Re: Conditional Approval of Data Gaps Investigation Work Plan

- **Site Name:** Solid Wood Inc.
- **Site Address:** 700 W Bay Dr NW, Olympia, Thurston County, WA 98502-4838
- **Facility/Site No.:** 94656838
- **Cleanup Site ID:** 4228
- **Agreed Order No.:** DE-08-TCPSR-5415

Ecology comments transmitted July 26, 2022, on the *Data Gaps Investigation Work Plan for the City of Olympia's Solid Wood, Inc. Site in Olympia Washington*, May 4, 2022, prepared by Pioneer Technologies Corporation.

Figure 1: 1961 Air Photo showing historical log storage and area needed for sediment characterization for wood waste impacts.

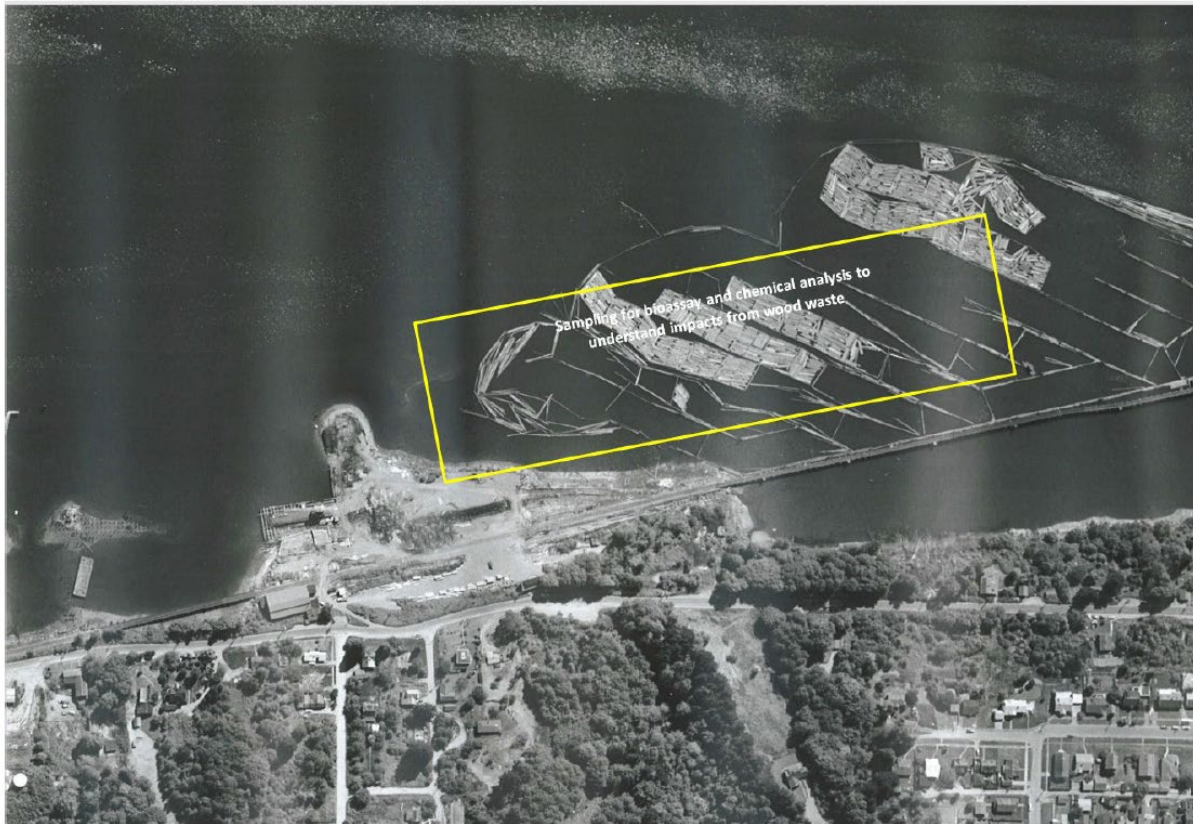
5. Figure 2-2: The sample area for sampling historical log rafting activities in Figure 2-2 (box outlined with red dotted line) is significantly larger than the suggested sample area indicated in Figure 1 from Ecology's May 19, 2021 comment letter (see yellow outlined box below). **Please reduce the size of the proposed sample area to be more consistent with Ecology's comment letter or provide an explanation of why it is appropriate to investigate the larger area shown in Figure 2-2.** Ecology's concern is that a too large a sample area will require more field time and expense than necessary plus there will be an increased likelihood that fewer samples will be from the main historic log storage area.
